PLANNING BOARD AGENDA
January 13, 2026 – 6:00 p.m.
City Council Chambers, 60 Court Street

Re: PUBLIC HEARING/ SITE PLAN and FINAL SUBDIVISION REVIEW: 15 Academy Street (PID 230-132): Application by Gorrill Palmer on behalf of Auburn Town Center Apartments, LLC for the construction of a 53-unit residential development. This property is in the Traditional Downtown Neighborhood (T-4.2) district and will be reviewed under Chapter 60, Article XVI, Division 2 – Site Plan Review and Division 4 – Subdivision.

Re: PUBLIC HEARING/ SITE PLAN and PRELIMINARY SUBDIVISION REVIEW: 15 Academy Street (PID 230-132): Application by Gorrill Palmer on behalf of Auburn Town Center Apartments, LLC for the construction of a 53-unit residential development. This property is located in the Traditional Downtown Neighborhood (T-4.2) district and will be reviewed under Chapter 60, Article XVI, Division 2 – Site Plan Review and Division 4 – Subdivision.

Drawing No.  
**C-3.0**

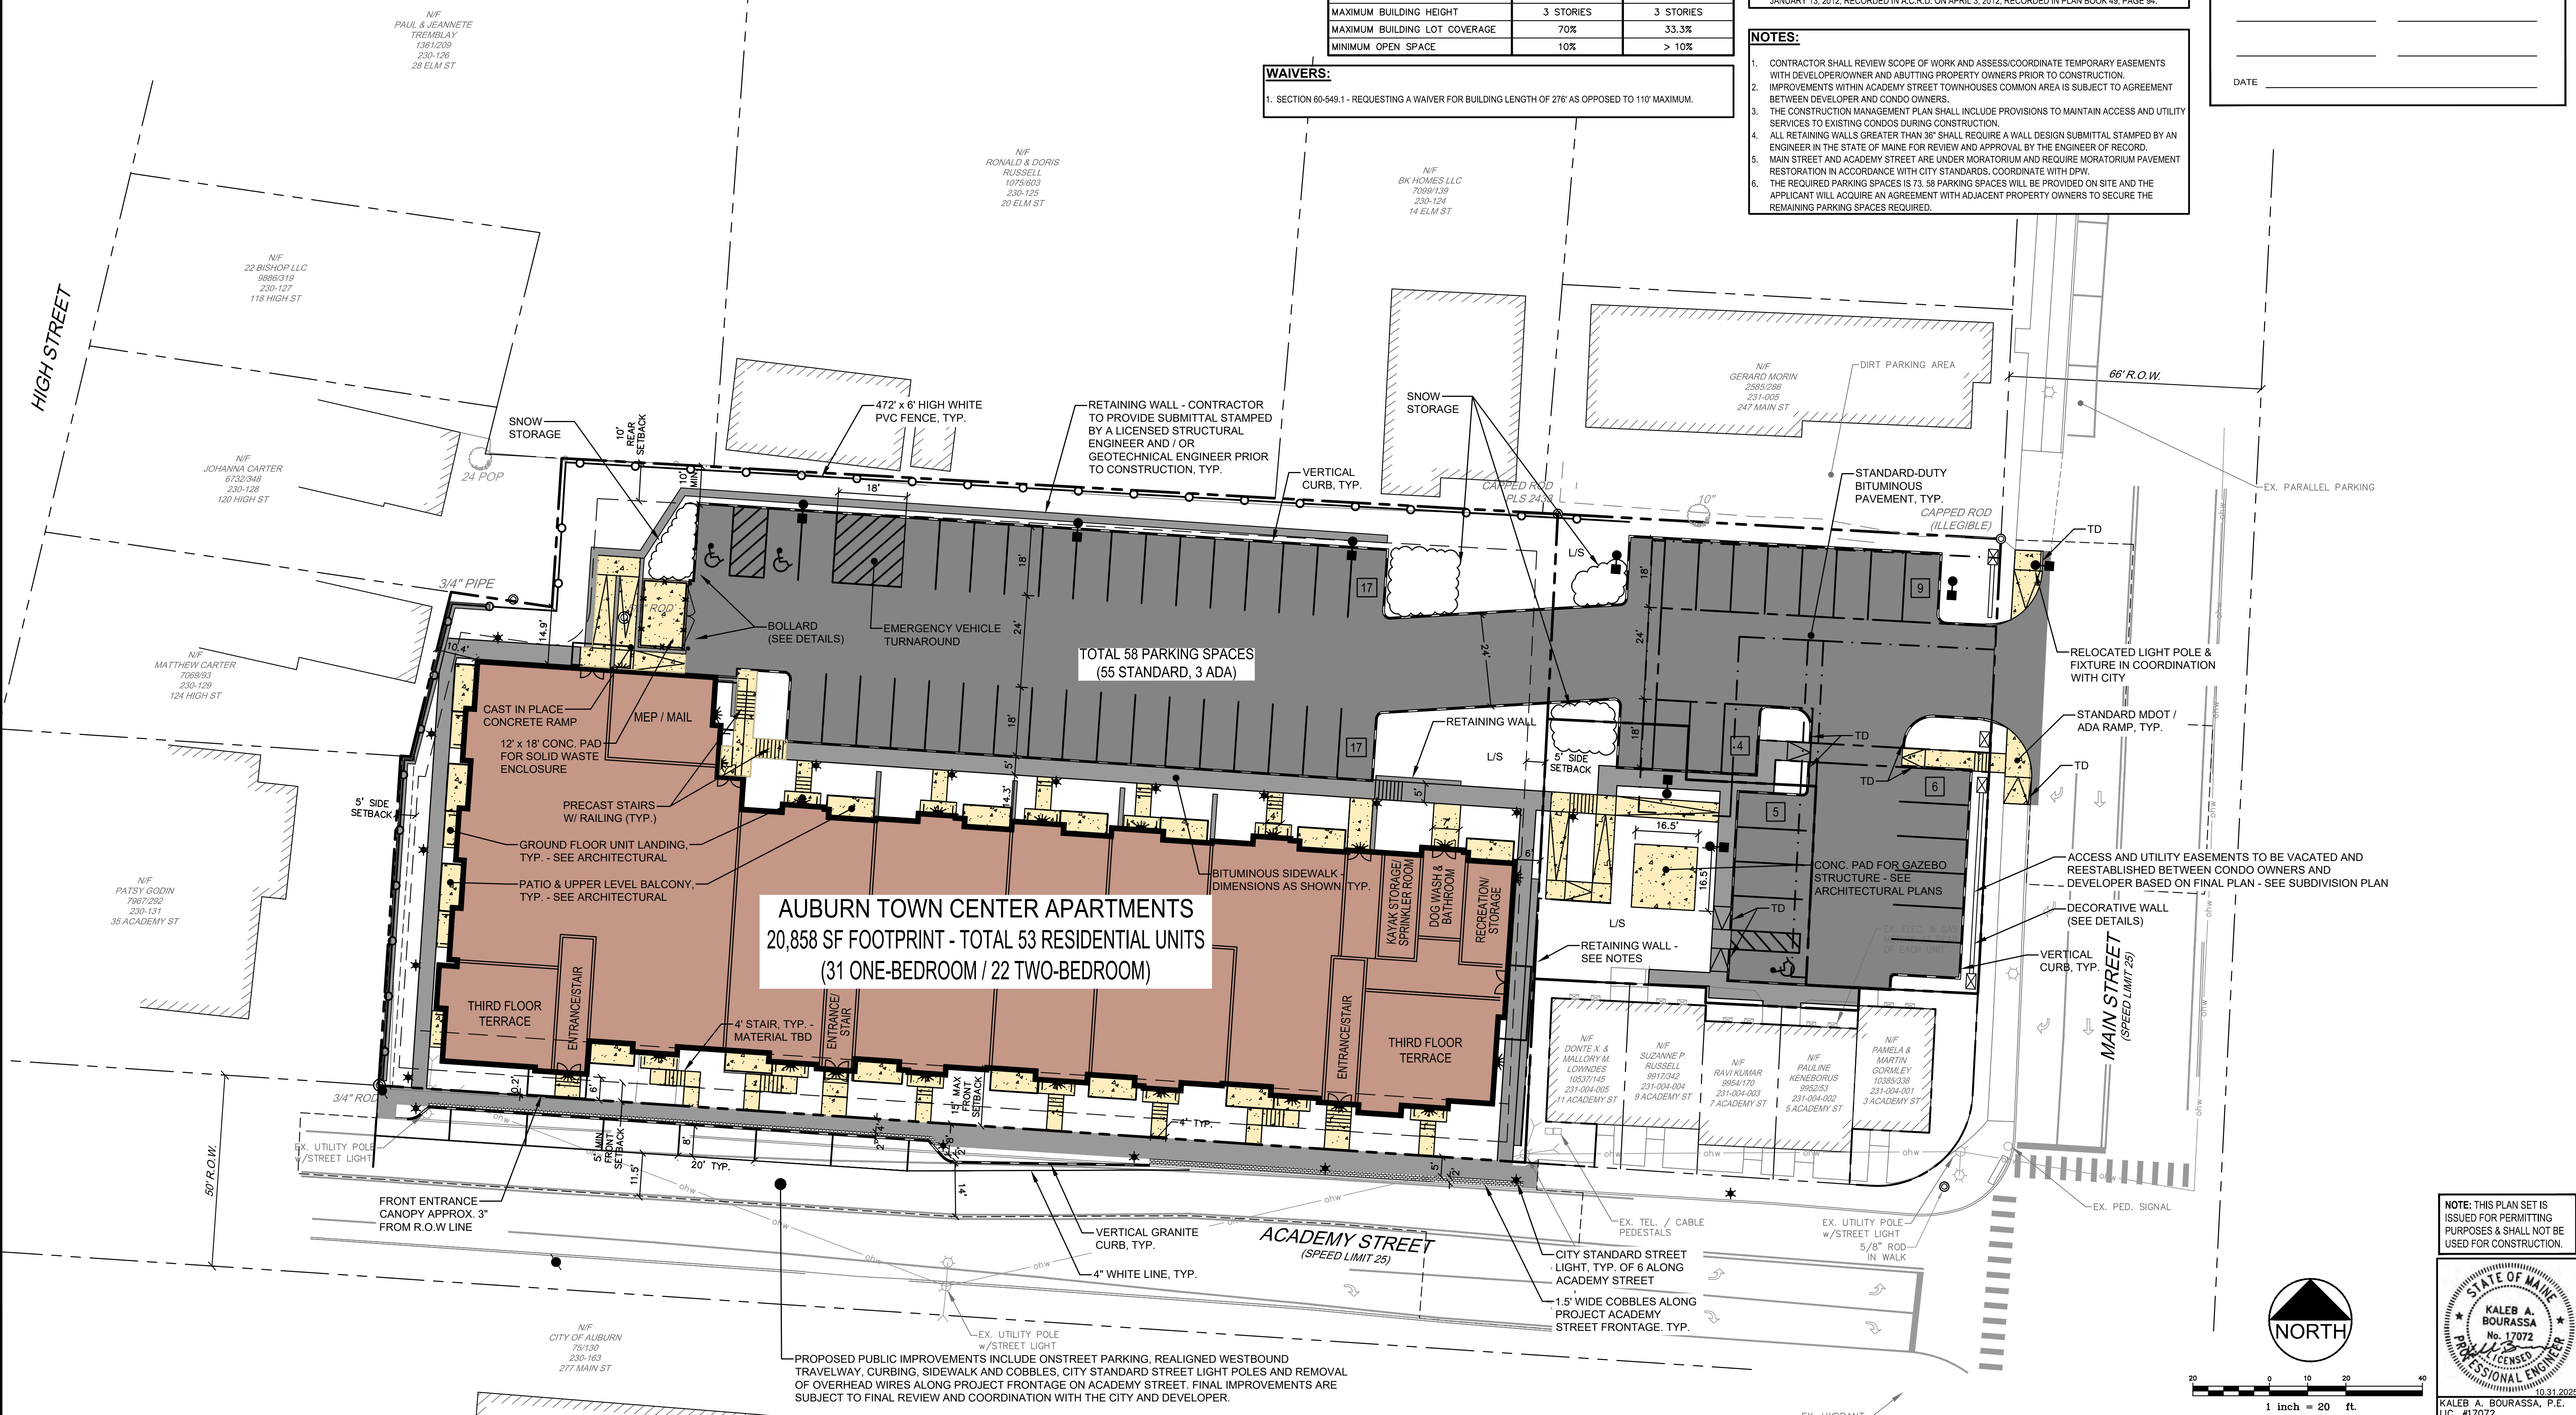
11. *As noted on Sheet C-3.0, Main Street and Academy Street are subject to pavement moratoriums. Any activity must be coordinated with MDOT and Auburn Public Works.*

15. *Sheet C-3.0: Building setbacks should be shown, particularly those related to the requested waivers.*

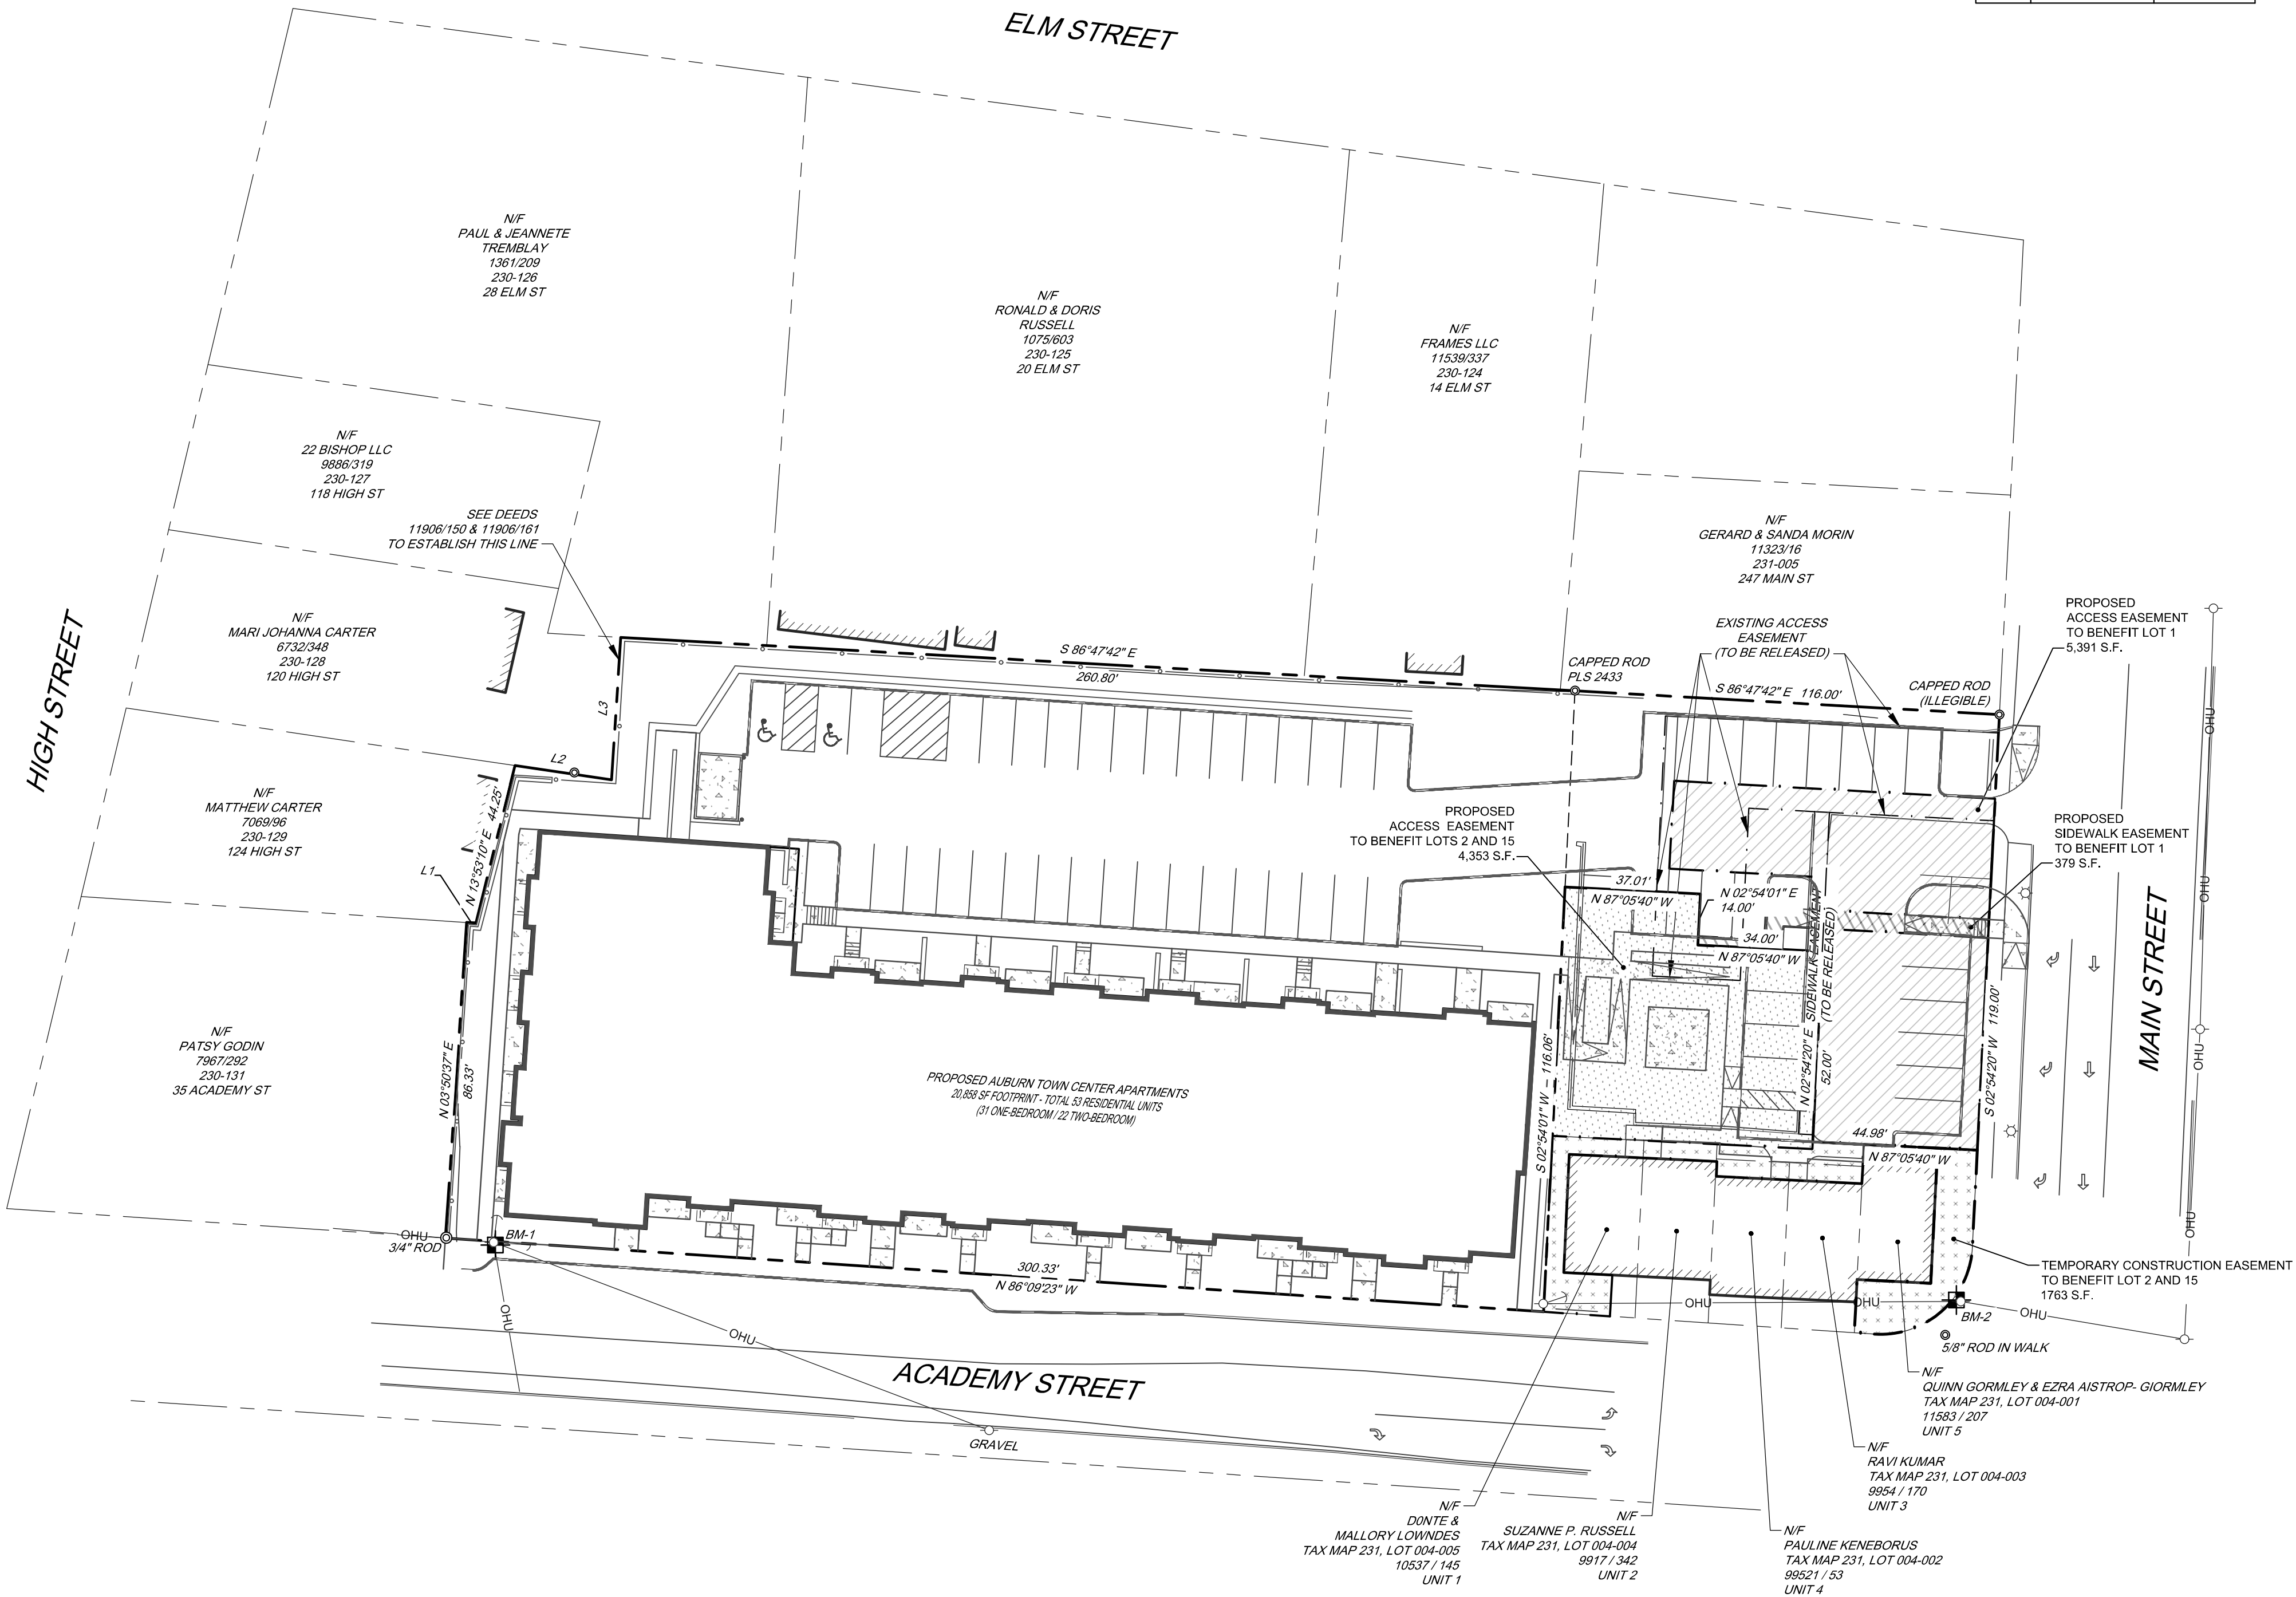
17. *Subdivision Plan (Sheet 1 of 1): References to waivers should be corrected: Waiver #4 is not a waiver, but rather a Planning Board finding. Pending Planning Board approval, the note should be revised to reflect how parking requirements are being met.*
